Re: The Chemours Company (Chemours)
Pompton Lakes, Passaic County, New Jersey

Response to Comments Document for Chemours' Permit-By-Rule Proposal

The following are the Department's responses to public comments received on Chemours' application for a NJPDES-Discharge to Ground Water Permit-By-Rule. Chemours' proposal was detailed in the document entitled *Implementation Work Plan-Hydraulic Surcharging Pilot Study*, dated May 2016.

Figure 3 - Recovery Well 65 Pumping 0 Gallons Per Minute

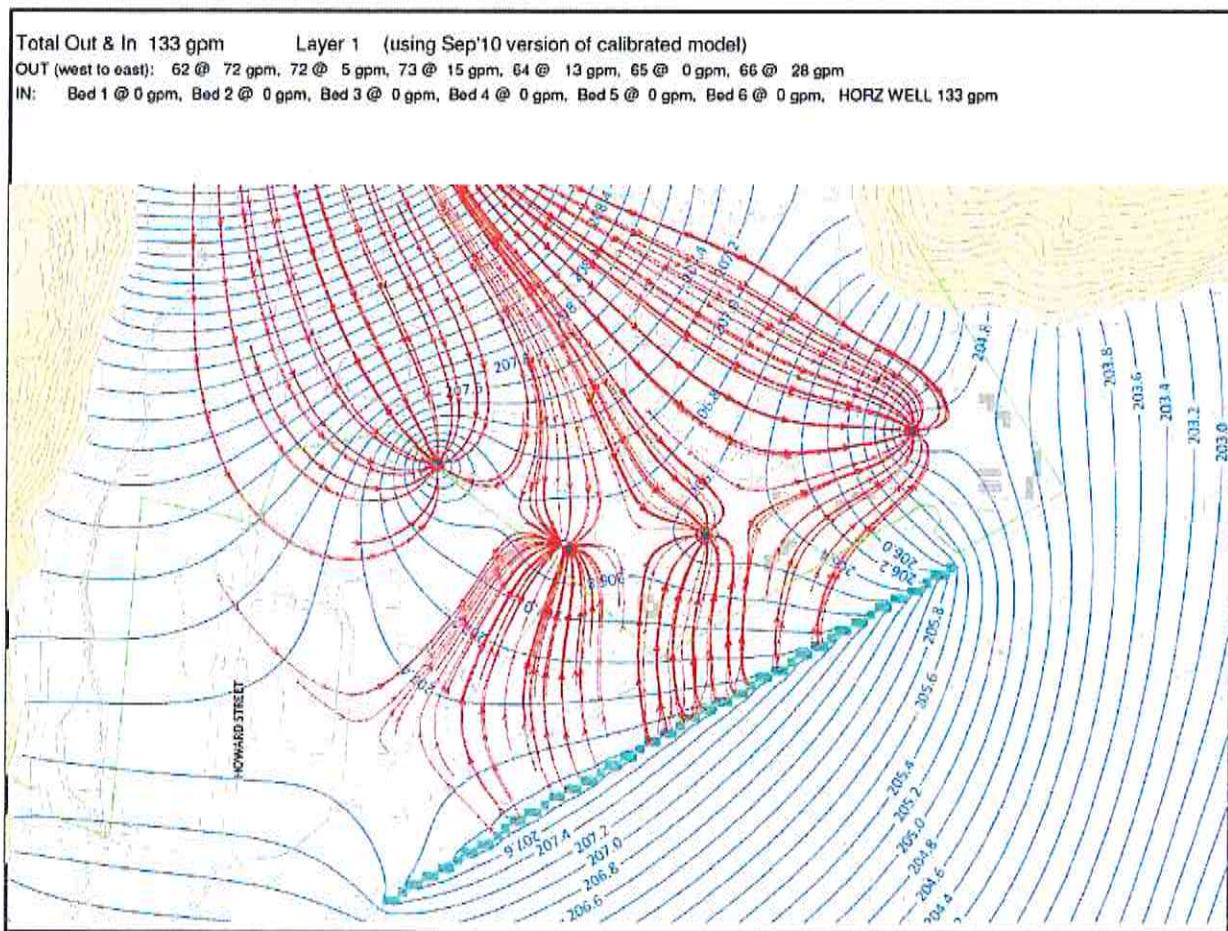
By extending the horizontal well to the end of Grant Avenue, Chemours would attempt to direct the discharged water into the shallow aquifer to flush the western portion of their plume south towards Pompton Lake, and north towards the on-site extraction wells. With greater distance from the injection well, groundwater would begin to conform to the regional flow direction and would not be expected to create a mound large enough to overcome that flow. The figure below illustrates the modeled groundwater contours and expected flow lines.

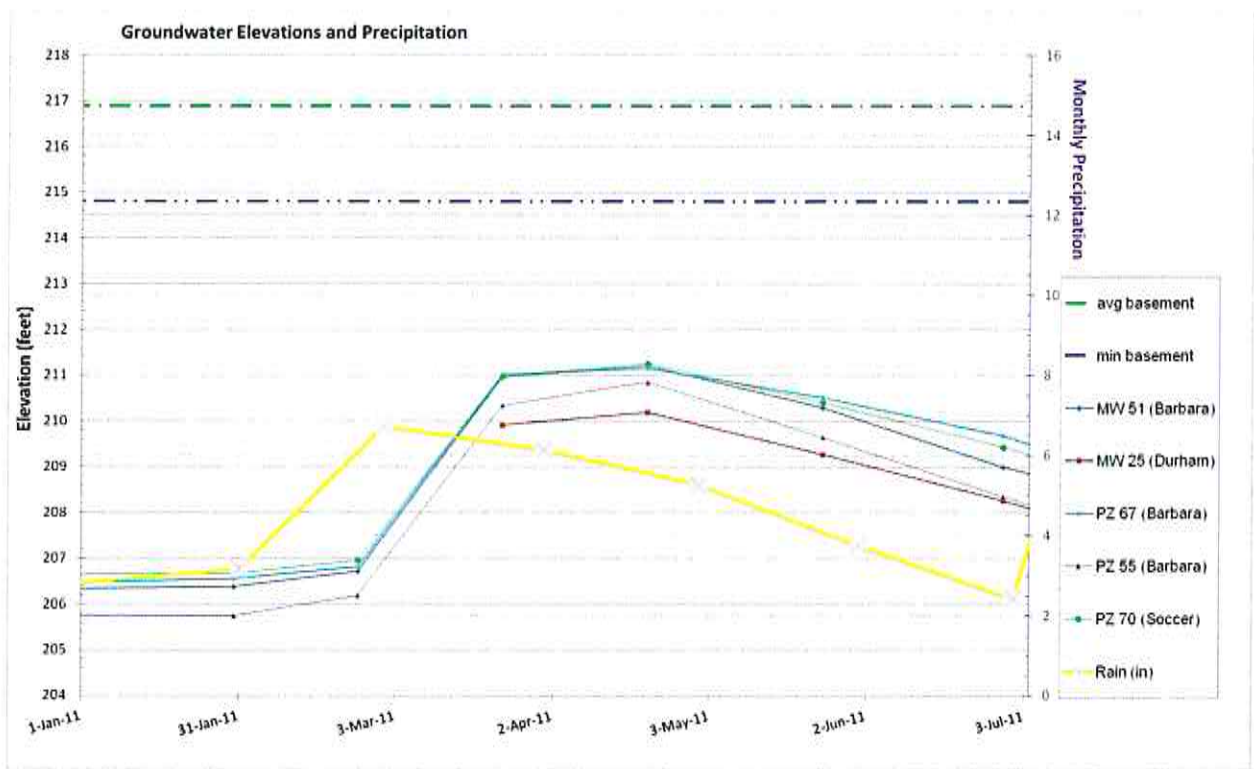
- In the spring of 2011 the flow to the infiltration beds located proximate to the eastern end of Barbara Drive was increased from 125 to 140 gpm, This resulted in the flooding of the basements of homes located on Barbara Drive across from those fields. Consequently, the above statement should be revised as it fails to recognize this the historic flooding of basements caused by the existing discharge to groundwater.

- Response: The current pilot study proposes to reinject the same amount of water as is currently infiltrated using the localized infiltration beds. This would spread water infiltration over a larger area reducing the maximum observed water table rise. However, the placement of the well along the railroad track would result in some elevation of the water table in the neighborhood adjacent to the horizontal well. The groundwater flow model used for design of the system projects a relatively small increase (e.g., 1-2 ft) due to the reinjection well. The model was also used to project the increase in water table elevation in a situation where the average hydraulic conductivity of the shallow zone has been underestimated by an order of magnitude which is a very unlikely situation. This type of analysis provides a degree of confidence that water levels should not rise enough to impact basements under normal conditions. The piezometer/well spacing of approximately 200-400 ft along the horizontal well should provide sufficient coverage to allow detailed evaluation and control of the increase in groundwater elevation during the study. The Department acknowledges that enhancements to monitoring frequency and design could increase confidence in the program.

The Department is not aware of reports that basements of homes were flooded along Barbara Drive in Spring of 2011 *as a result of operation of the GWET system*. The GWET system extracted an average monthly flow rate of 111 gpm for March, April, and May 2011 compared to a rate of

128 gpm for the previous months (December, January, and February). Water was discharged to all 12 infiltration beds (6 pairs) of which only 6 beds (3 pairs) are along Barbara Drive. The beds along Barbara Drive received approximately 60% of the total flow from March 1st through May 2011 (which was lower than the previous months).

As shown on the graph below, water table elevations were lower in the months prior to the Spring 2011 reference (while discharge was higher) as compared to the Spring 2011 elevations (while discharge was lower).

As can be seen on the graph below, water table elevation changes appear to mirror times of higher precipitation (there is always a lag as it takes time for surface water to infiltrate to the water table) and the peak can be directly attributable to the almost two-fold increase in precipitation from January to March (6.7" in March, 6.14" in April, and 5.26" in May).

Figure B: Predicted Mounding at Schuyler Avenue

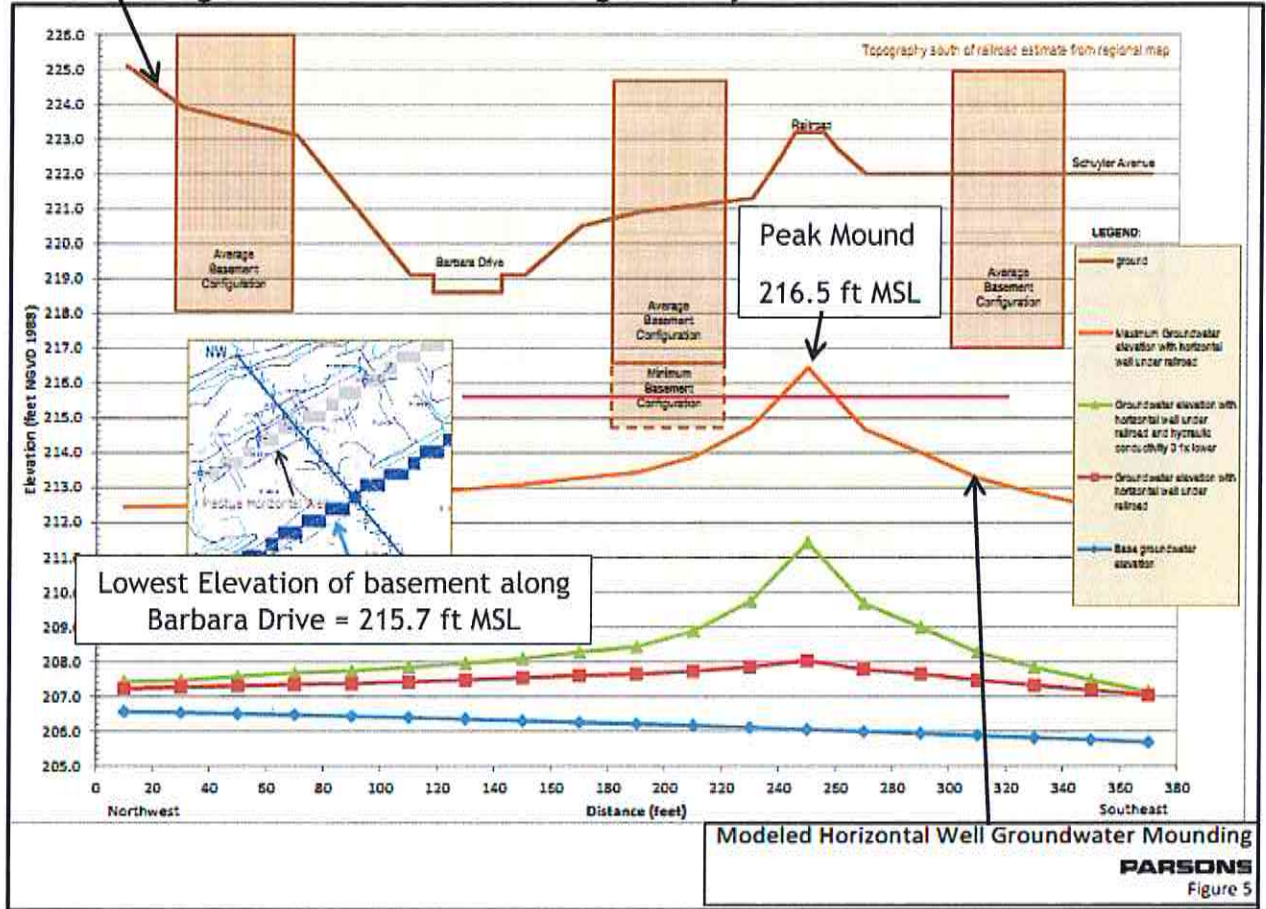
- Figure B is Figure 5 referenced above was excerpted from the IWP. This has been annotated with elevations of homes along Barbara Drive. Figure B shows multiple homes that are at risk of flooding along Barbara Drive and contradicts the statements in the IWP text. An explanation of these contradictions and revisions to the IWP are required.

- Figure B summarizes modeling conducted for the IWP. The results, based on the IWP’s Figure 5 are the same as presented in the BOD; the horizontal well is shown capable of elevating the water table above the basement elevation of homes along Barbara Drive. An explanation of this contradiction between text and figure and revision of the IWP text is required

➤ Response: The figure being referenced shows multiple water table elevations based on various operating scenarios using different physical characteristics of the aquifer.

- The upper line represents the water table predicted elevation assuming a steady state discharge rate of 129.5 gpm, the lower hydraulic conductivity range for the aquifer [$\sim 6.5\text{-}7$ ft/d], and a scenario in which 5 feet is added to simulate a higher water table level if that were to occur.
- The next lower line represents the proposed steady state discharge rate of 129.5 gpm and the lower hydraulic conductivity range for the aquifer [$\sim 6.5\text{-}7$ ft/d] with no simulated increase in water table elevation.
- The next line represents groundwater elevations using the proposed steady state discharge rate of 129.5 gpm and hydraulic conductivity measured during other investigations in the shallow aquifer [$\sim 65\text{-}70$ ft/d] with no simulated increase in water table elevation.

As shown on the figure, the groundwater elevation mound peaks above the horizontal well, but slopes quickly away from the source of infiltration (the well).

The figure also shows the edges of houses much closer to the horizontal well than what actually occurs. A revised figure is provided as part of a later comment response.

- Response: The 'Lowest Elevation of basement along Barbara Drive', as shown on the figure, is 214.7 feet. The actual groundwater mound is not flat, but slopes away from the horizontal well as the orange-brown and green lines on the cross-section show.

Key" house# [elevation]

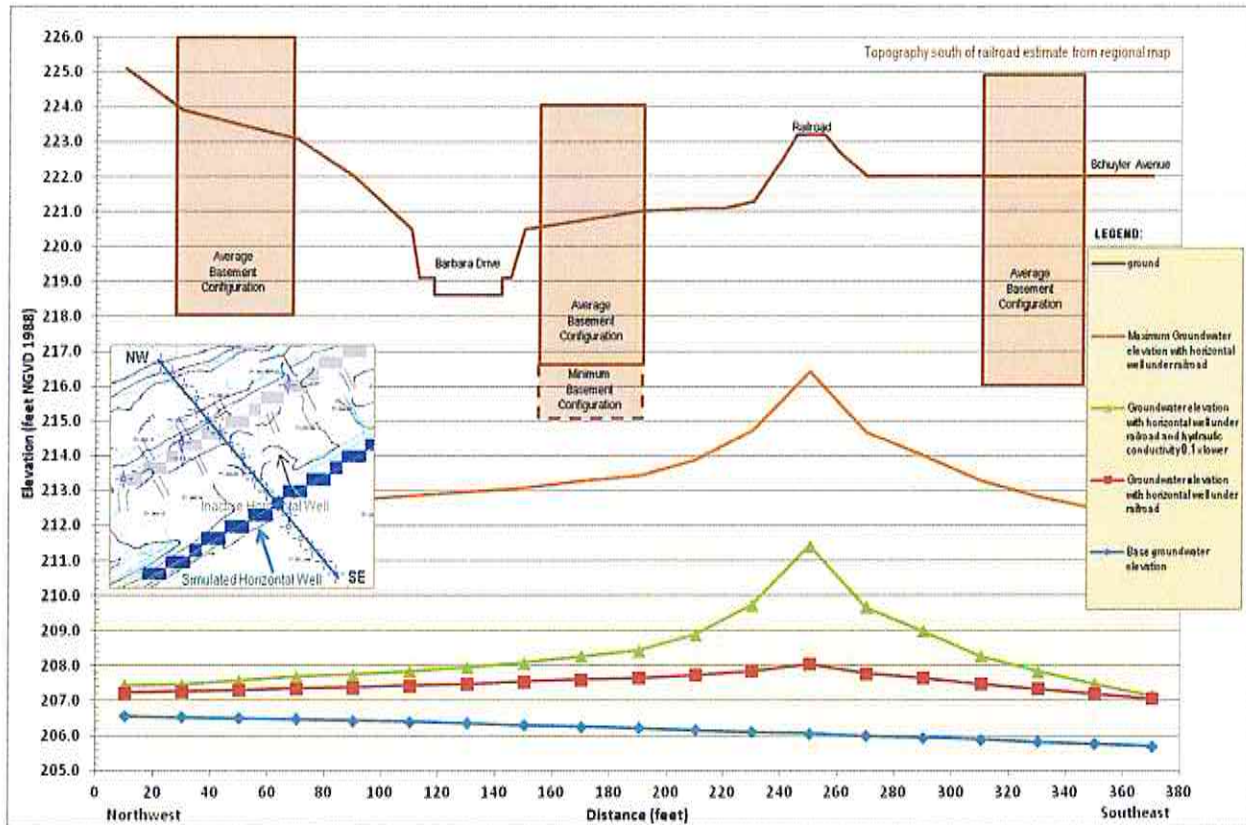
12 [216.2 ft MSL]; #18 [215.7 ft MSL]; #22 [216.4 ft MSL]

#34 [216.2 ft MSL]; #64 [216.3 ft MSL]; #88 [216.0 ft MSL]

- Response: The homes referenced in the box above are approximately 70 feet away from the northern edge of the railroad, only #22 is closer at 60 feet. If the well is located along the southern portion of the rail, it would add approximately 15 feet of distance away from the well for all houses. Given this information, along with the extensive water level data collected and modeling completed, the Department is confident that there would be little risk for basement flooding. A revised figure illustrating these field conditions is shown below.

- Figure shows modeled mounds with 130 gpm flow to horizontal well and varying subsurface hydraulic conditions. Peak mound predicted to occur "...If the hydraulic conductivity of the shallow groundwater zone is lower than currently estimated, and an above average high water table exists due to higher than normal precipitation and recharge..." Those specific conditions not specified.
- Response: The upper line in the figure illustrates the predicted mounding using a proposed discharge rate of approximately 130 gpm and lower hydraulic conductivity range for the shallow aquifer. It also includes a 5-foot rise in the water table to represent a high water table condition.
